**Inland Rail Narromine to Narrabri project – Preferred Infrastructure/Amendment Report – Revision E BDAR**

## BCS's Summary of Recommendations

### Inland Rail Narromine to Narrabri (N2N) – Preferred Infrastructure/Amendment Report – Revision E BDAR

## BCS's Review of Updated BDAR (Revision E)

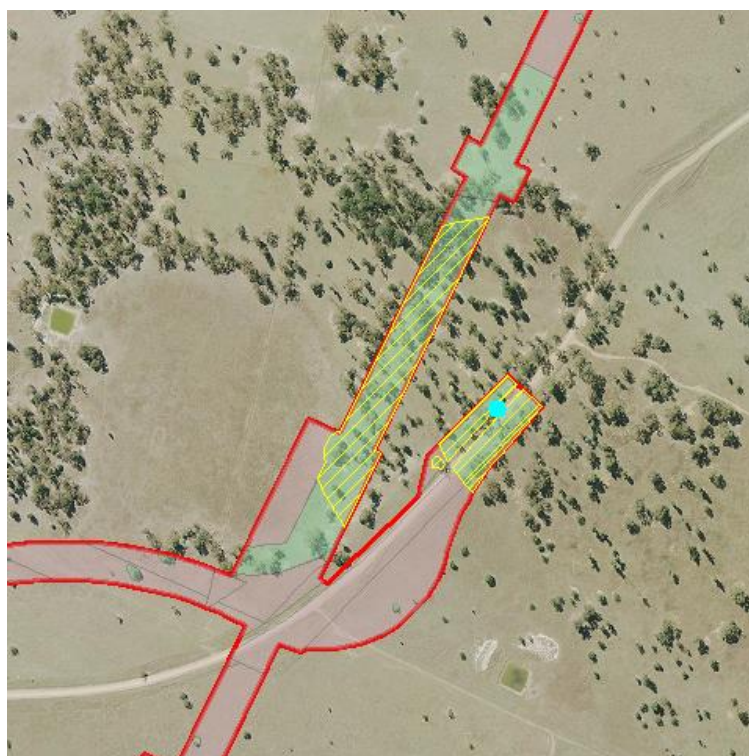
Additionally, BCS notes that a polygon has been added to the Koala species polygon for the area of habitat associated with a Koala scat record located to the northwest of Gilgandra during the field surveys completed to inform the expert report. It is not clear from the expert report how the extent of this polygon was determined. The polygon (shown below in yellow hatching) does not include the full extent of PCT 56 in the broader vegetation patch.

- 6.5 Provide justification for the Koala species polygon extent associated with the Koala scat record located to the northwest of Gilgandra.
